May 12, 2021

Product Change Notice - Gen I Patio Wall Armor moving to Gen II due to supply shortages

Fig.1

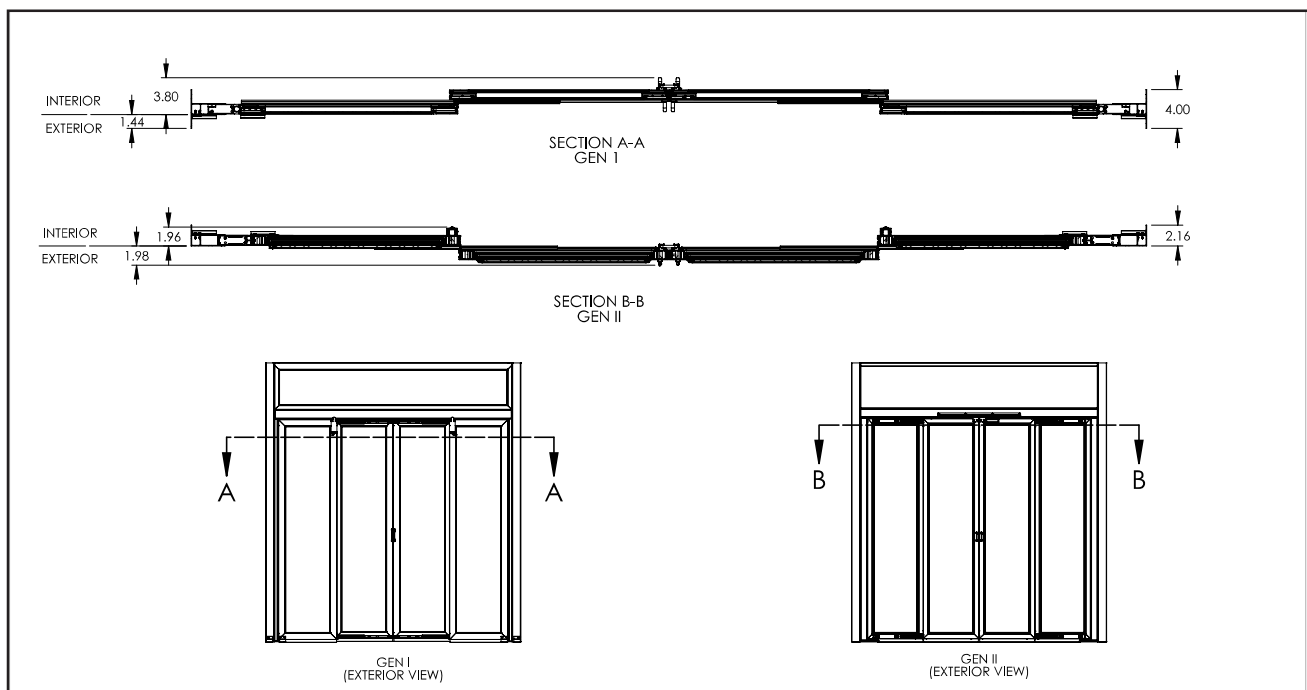
Like Gen I, the Gen II system will come with screens only. The Gen II system uses glass panels instead of vinyl and has a foam header panel instead of a tin header panel. There is also a difference in rail thickness. See Fig. 1 for details showing the overall thickness is thinner in Gen II. For installation, existing wall angles can still be used for Gen II.
